Re: Downtown Enhancement Project - Selkirk Avenue (225 St. - 226 St.)

Upon studying the drawings for the design of the section of Selkirk Ave. between 225th and 226th Streets, we would like to make the following recommendations:

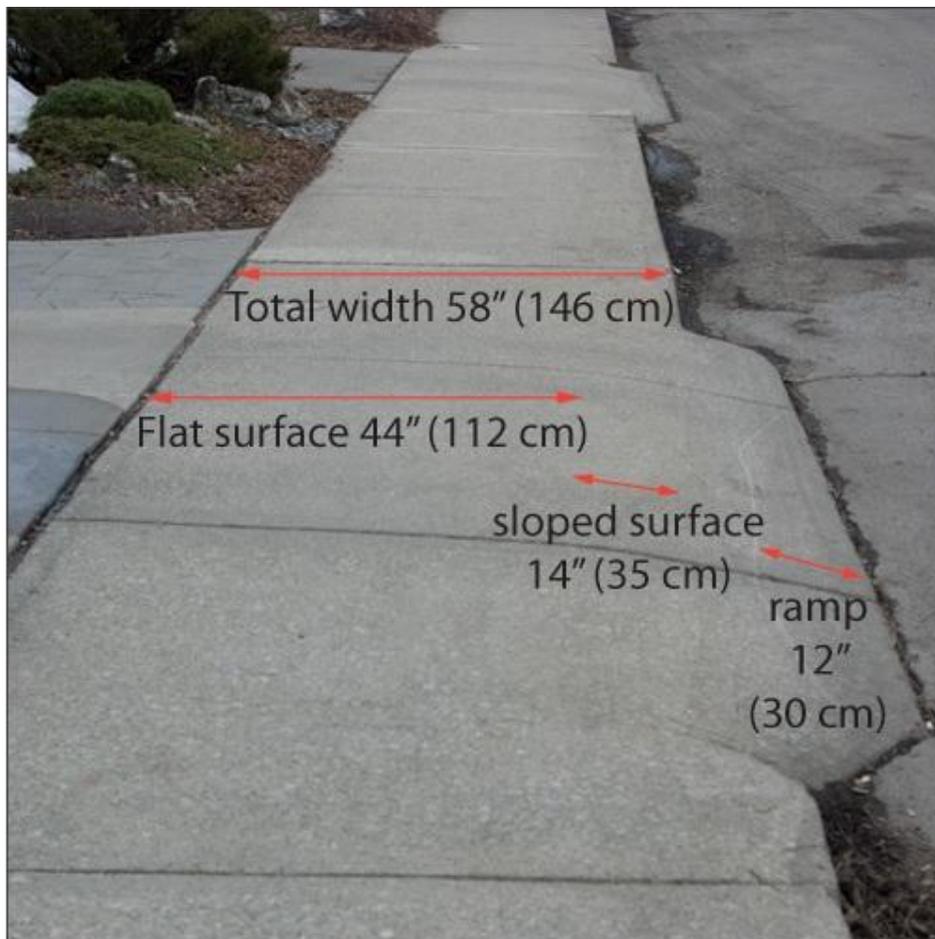
- Now that we're finally getting a sidewalk along the south side of this section of Selkirk, it's important to make it a **high quality sidewalk**, i.e. a facility that first and foremost serves pedestrians. This means a level walking surface along the length of the sidewalk, as opposed to the 'roller coaster ride' that pedestrians on the sidewalk on the north side are getting. The following is an example how this can be achieved at the driveway entrances:

There should be no obstructions on the sidewalk, so that people with strollers, scooters and walkers can easily, comfortably and safely use the sidewalk. It should also be possible for two people to easily walk side by side along the entire length of the sidewalk, without being obstructed by hydro poles, bollards, hydrants or other obstacles. Letdowns should be wheelchair/scooter-friendly.
